ATTACHMENT I TO JPN-88-037

PROPOSED TECHNICAL SPECIFICATION CHANGES REGARDING
RELOAD 8/CYCLE 9 (JPTS-88-016)

JAMES A. FITZPATRICK NUCLEAR POWER PLANT

SAFETY EVALUATION FOR
PROPOSED TECHNICAL SPECIFICATION CHANGES REGARDING
RELOAD 8/CYCLE 9 (JPTS-88-016)

Figure 3.1-1

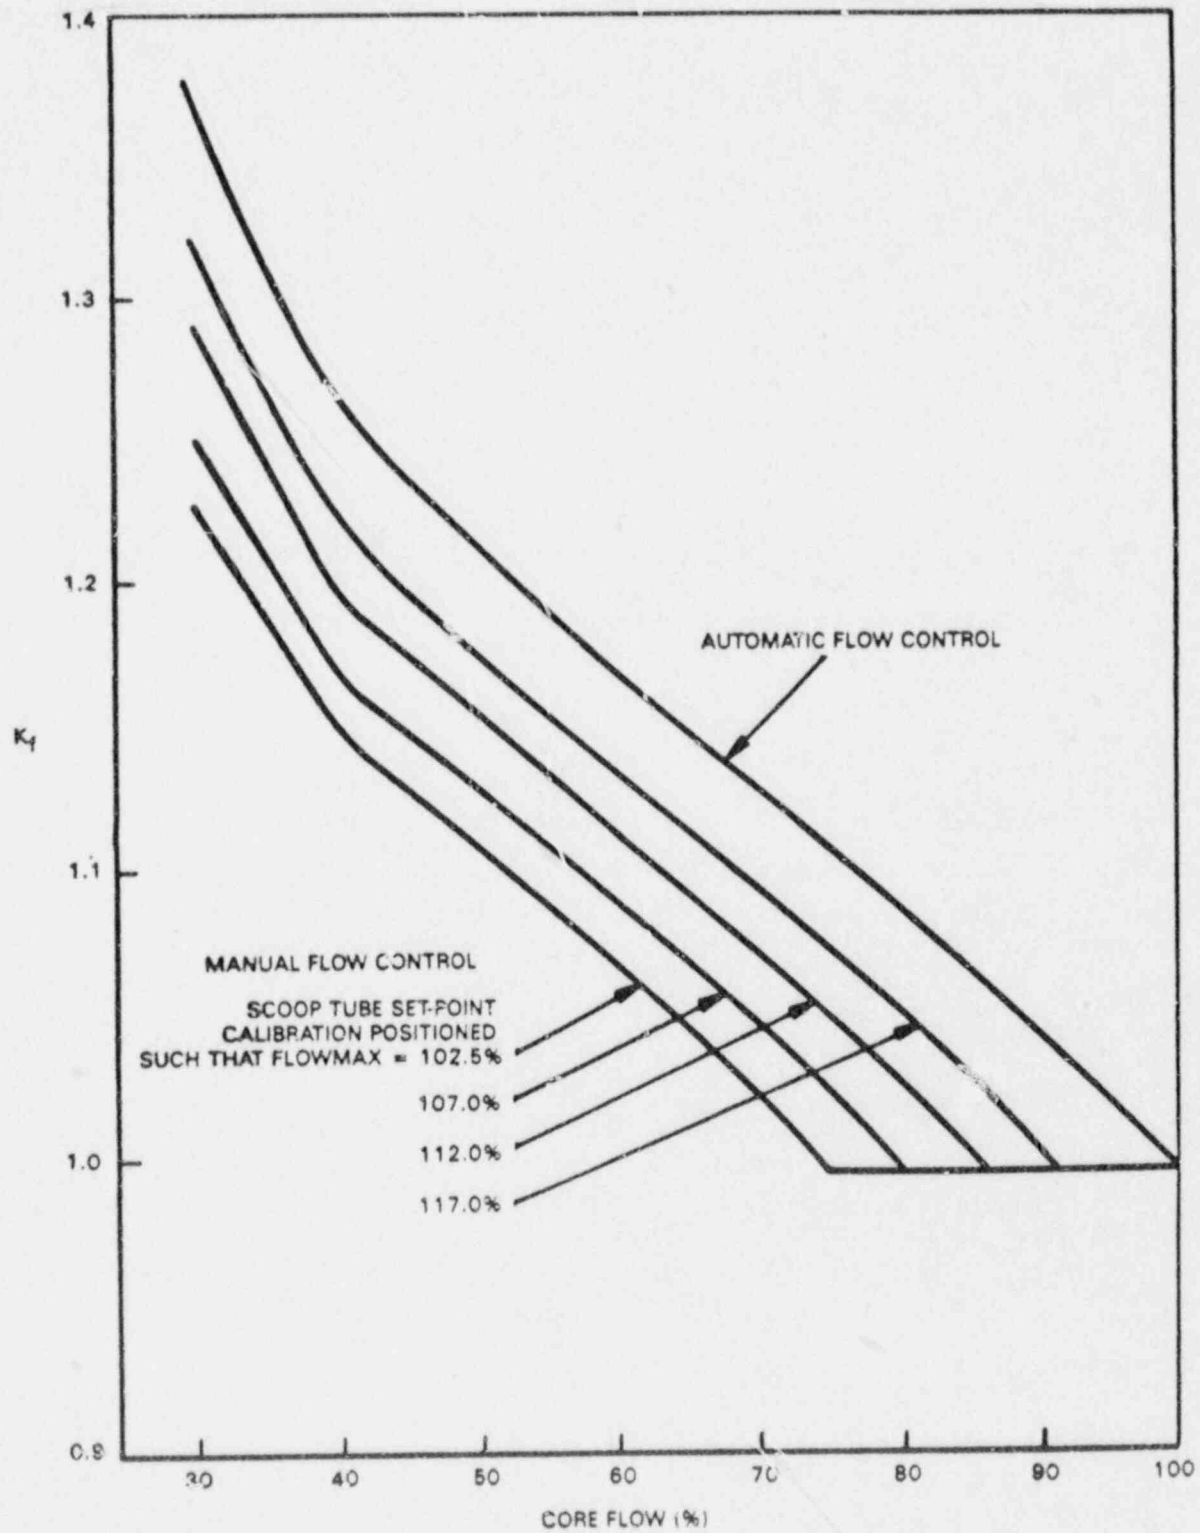
- [j] Replace the existing figure with one approved for use with the GEXL-PLUS correlation. See Attachment I for the new figure.

Figure 3.1-2

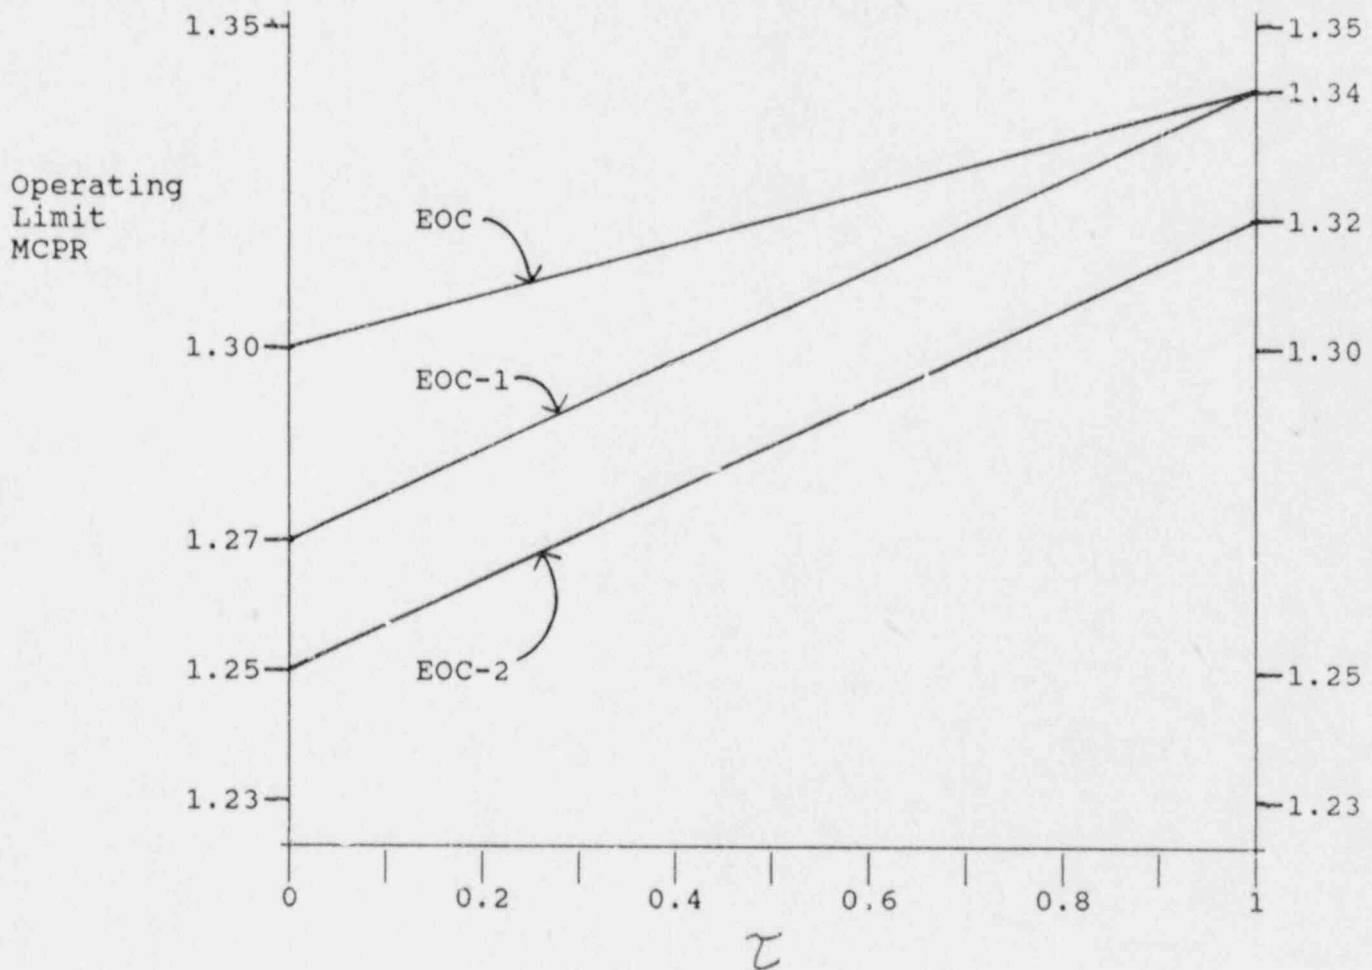
- [k] Replace the existing figure with one specific for Cycle 9 operation. See Attachment I for the new figure.

Figure 3.5-13

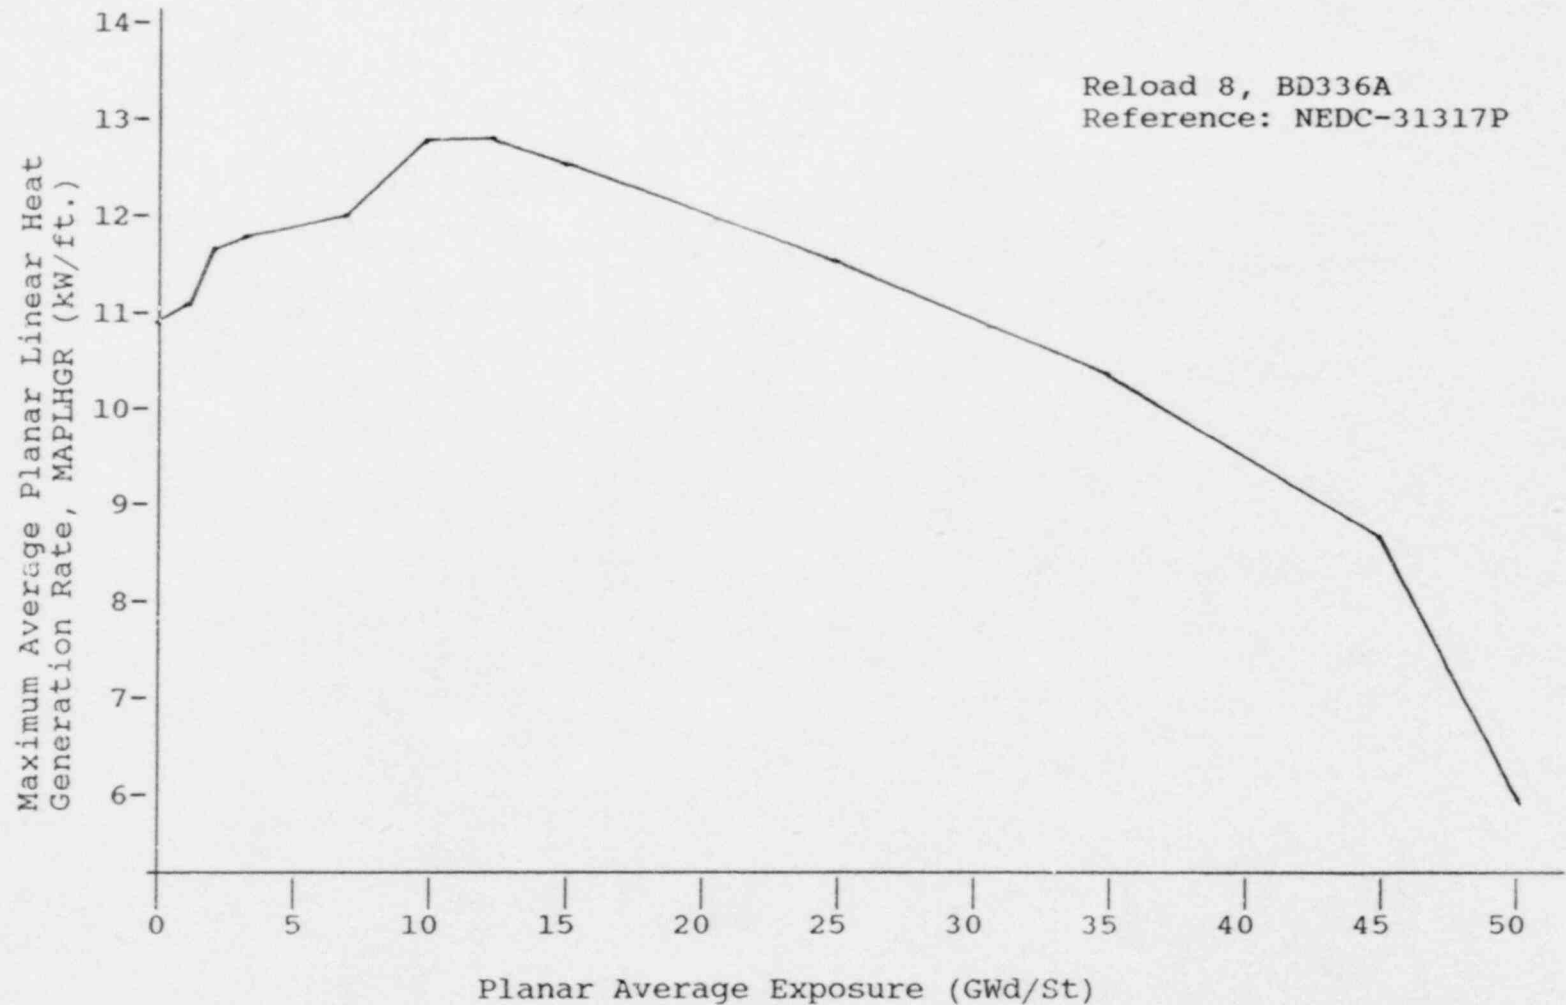
- [o] Add new figures prescribing the MAPLHGR limit vs. Average Planar Exposure for fuel types BD336A (page 135k) and BD339A (page 135L), added as Reload 8.

The fuel to be added in Reload 8 is similar to that added in Reload 7 in that it contains several lattice types of varying gadolinium content. To determine the proper MAPLHGR value for a particular axial location in a fuel bundle, the MAPLHGR tables contained in Reference 8 will be programmed into the plant process computer and backup computer system. When hand calculations are necessary, the most limiting enriched uranium lattice MAPLHGR value is applicable. The exposure dependent limiting MAPLHGR values are shown in Figures 3.5-13 and 3.5-14 on pages 135k and 135l for fuel types BD336A and BD339A respectively. The tables used to generate these figures are included in Attachment III.
